Access Compliance Report Public Rights-of-Way (Curb Ramps)

Main Street: KEMPTON_LN Cross Street: HEMPSTEAD_ST Location: NE

ADA ID: RPRK211021154134 Ramp Type: Type 4 - Parallel Initial Pass/Fail: Fail Overall Compliance: No Severity Score: 16

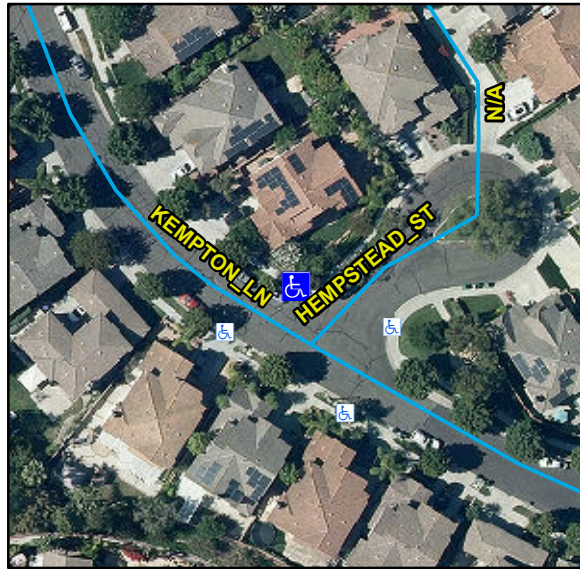
R204.3, R304.3.2, R304.5.3, STD 1115

Compliance	Description	Data	Compliance	Description	Data
N/A	Ramp Length LT (in)	113	N/A	Ramp Length RT (in)	111
Yes	Ramp Width LT (in)	53	Yes	Ramp Width RT (in)	53
No	Ramp Run Slope LT (%)	8.4	Yes	Ramp Run Slope RT (%)	6.8
No	Ramp Cross Slope LT (%)	3.6	No	Ramp Cross Slope RT (%)	3.3
N/A	Landing Present	N/A	N/A	DWS Provided	N/A
N/A	Landing Length (in)	N/A	N/A	DWS Contrast	N/A
N/A	Landing Width (in)	N/A	N/A	DWS Length (in)	N/A
N/A	Landing Run Slope (%)	N/A	N/A	DWS Full Width	N/A
N/A	Landing Cross Slope (%)	N/A		DWS Offset Type	N/A
N/A	Landing Movement Obstructed?	N/A	N/A	DWS Offset Left (in)	N/A
	Landing Movement Type	N/A	N/A	DWS Offset Right (in)	N/A
N/A	Landing Shared	N/A			
N/A	Clear Space	Yes			
N/A	Clear Space To Crosswalk (in)	N/A			
N/A	Marked Crosswalk 1	No	N/A	Marked Crosswalk 2	No
	Crossing 1 Direction	SW		Crossing 2 Direction	SE
	Marked Crosswalk 1 Width (in)	N/A		Marked Crosswalk 2 Width (in)	N/A

Remove & Replace Curb Ramp With Two New Directional Ramps or Equivalent.
